PanGEO
INCORPORATED
Geotechnical & Earthquake
Engineering Consultants

April 4, 2019
Revised August 5, 2019
File No. 14-128.200

Subject: **Response to Geotechnical Review Comments (Revised)**
Proposed Single-Family Residence
4634 E Mercer Way, Mercer Island, WA

PanGEO INCORPORATED	Proposed Development 4634 E Mercer Way Mercer Island, Washington	SITE AND EXPLORATION PLAN	
		Project No. 14-128	Figure No. 1

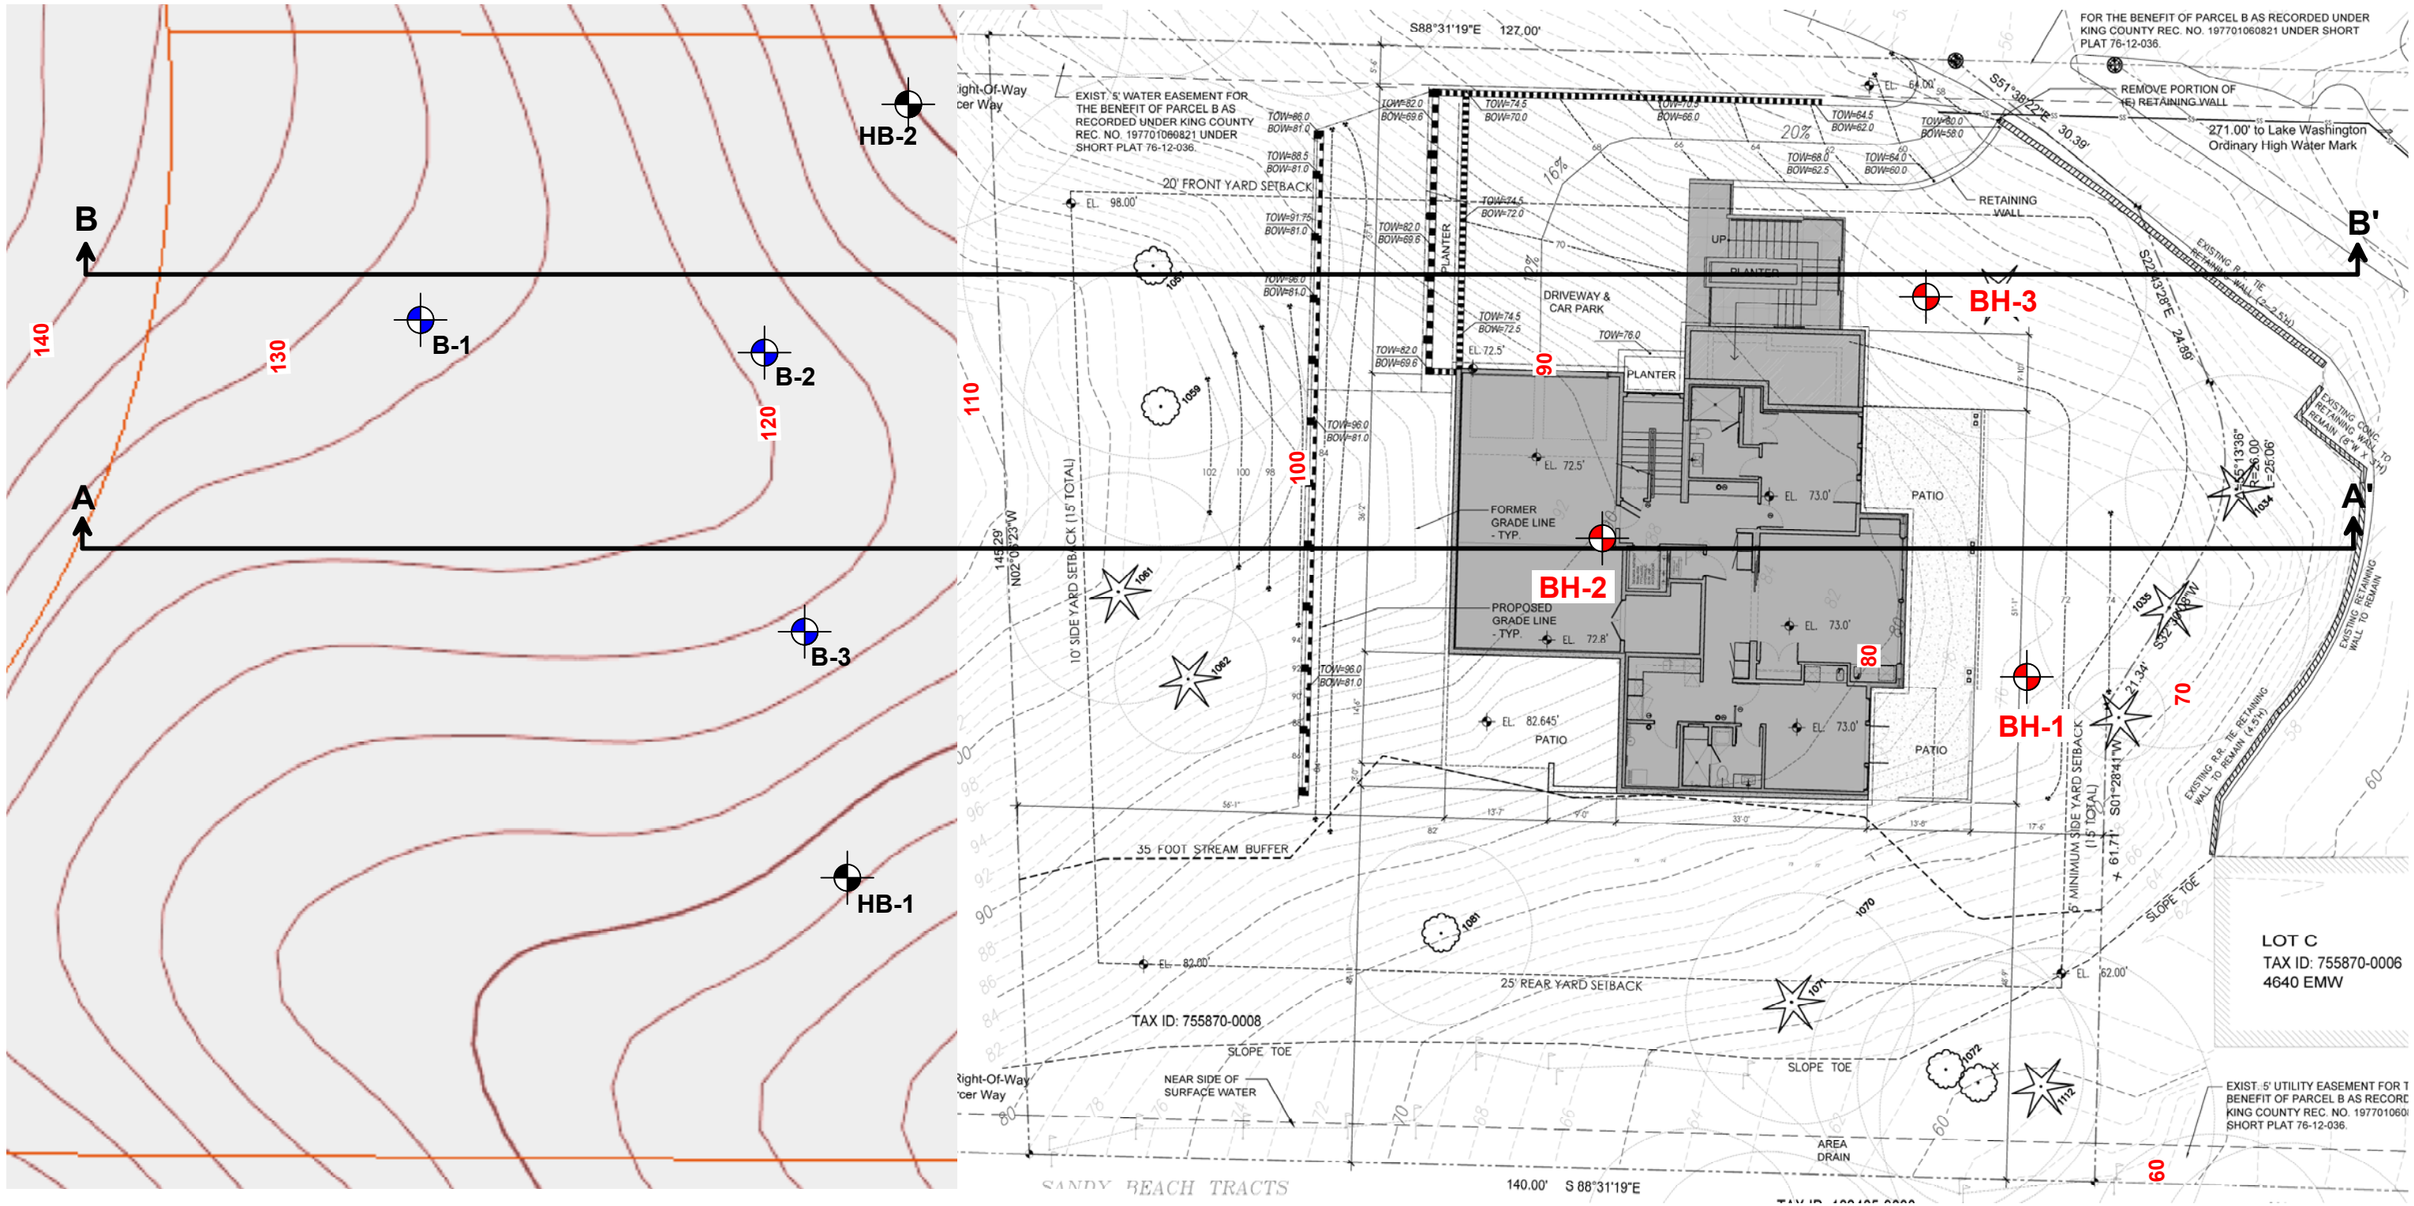
Two cross sections, A-A' and B-B, were created for the slope stability analysis. The approximate locations of the cross sections are shown on Figure 1. These two cross sections appear to be similar profile. As a result, the cross section A-A' was used for slope stability purpose, assuming a solider pile embedment depth of 14 feet (ie. soldier pile at B-B' condition).

During our current effort, we collected and reviewed the existing boring boring data on the adjacent property to the west (4630 East Mercer Way) competed by Agra Earth & Environmental in 1999. The existing exploration on 4630 E Mercer site consisted of three test borings and two hand borings. These existing borings generally encountered approximately 4 feet of loose to medium dense silty sand overlying medium dense to very dense silty sand and very stiff sandy silt that extended to a maximum exploration depth of about 11½ feet. Groundwater was not encountered within the drilling depths in the previous borings. The approximate locations of the previous borings and hand borings are also shown on Figure 1. The summary logs of the previous borings and hand borings are included in Appendix B for reference.

Static Slope Stability Analysis
Post-Construction Condition

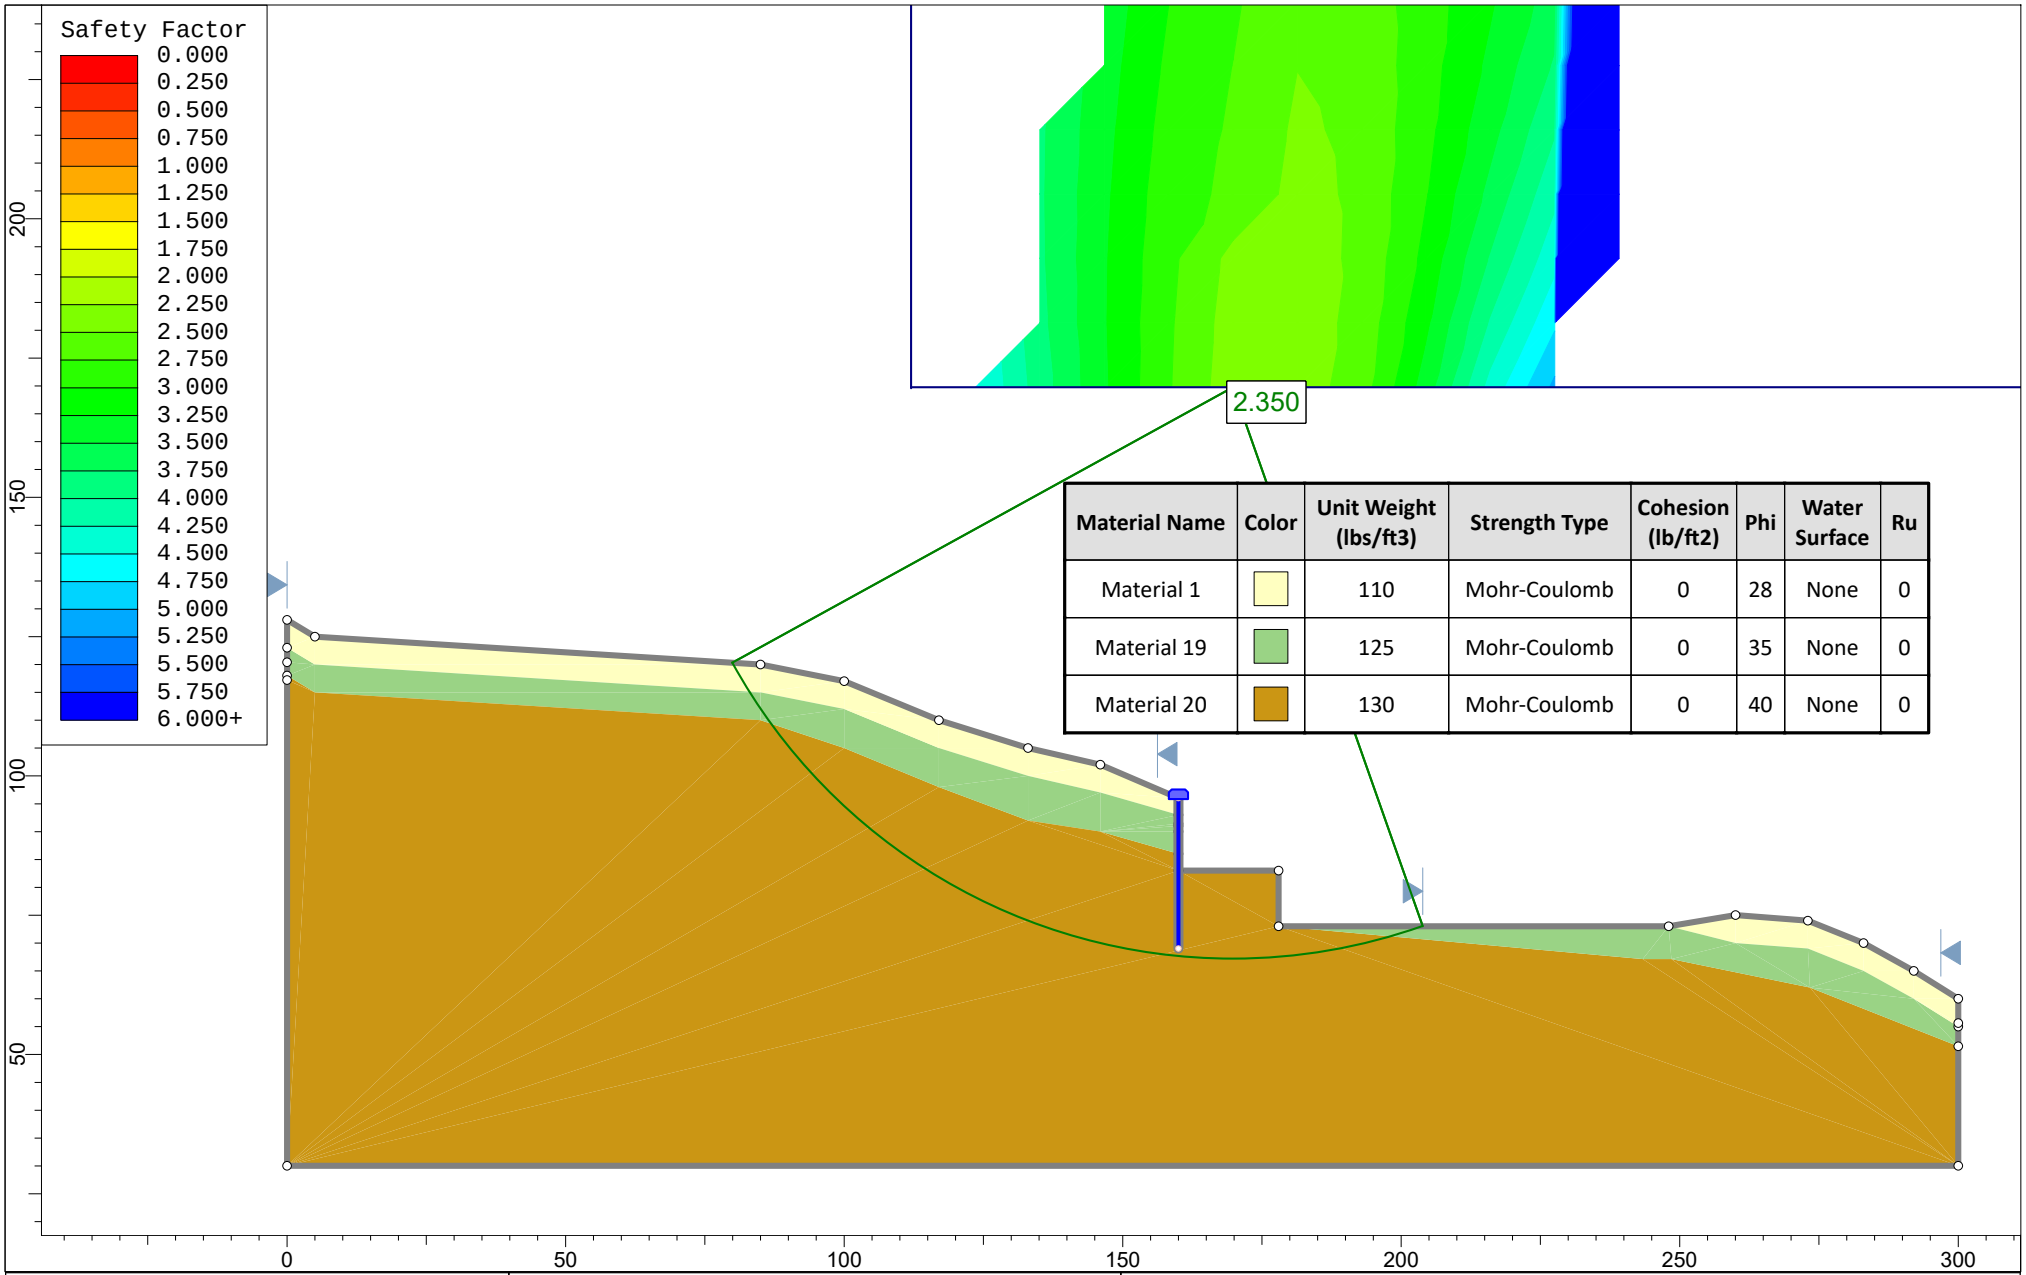
2. Overall Slope Stability analysis (Comment #2)

Our slope stability analyses were performed using the computer program *Slide v6.008* (Rocscience, 2010). The seismic stability was analyzed using pseudo-static procedures, where the effect of earthquake ground shaking is represented by the use of a "seismic coefficient" in the stability calculations. In our pseudo-static stability analysis, one-half of the expected peak ground acceleration, or 0.284g, was used. The results of our analyses are shown in Figures 4 through 8.

In summary, based on the results of our additional analysis and evaluation, it is our opinion that the site has the adequate factor of safety against potential failures under the static and seismic conditions, and will not likely have catastrophic slope failure that may threaten life safety of the occupants.

LOG OF TEST BORING BH-1

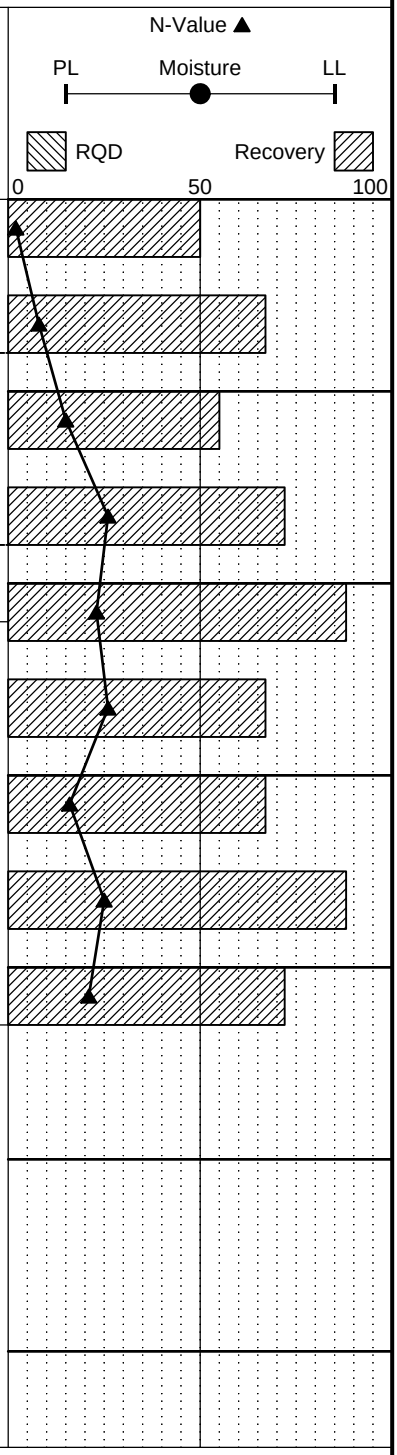
1. Subsurface Conditions (Comment #1)

PanGEO drilled three (3) test borings at the site in 2014 as part of our geotechnical study for the proposed development. Our borings generally encountered approximately 5 feet of loose to medium dense sand overlying medium dense to very dense silty sand to at least 21½ feet below surface. Groundwater was not encountered within the drilling depths in the borings. The borings are generally located in the proposed building area, but no borings were drilled in the upper slope areas west of the proposed house and soldier pile walls. The approximate boring locations are shown on Figure 1. The Figure 1 includes the adjacent property to the west to show the existing borings. The summary boring logs are included in Appendix A for reference. Based on our current review, we may have incorrectly assigned geologic unit for medium dense sand below 4 feet in

boring BH-1 and BH-2 as Colluvium. We believe that it is more appropriate to describe as Weathered Pre-Olympia Deposit).
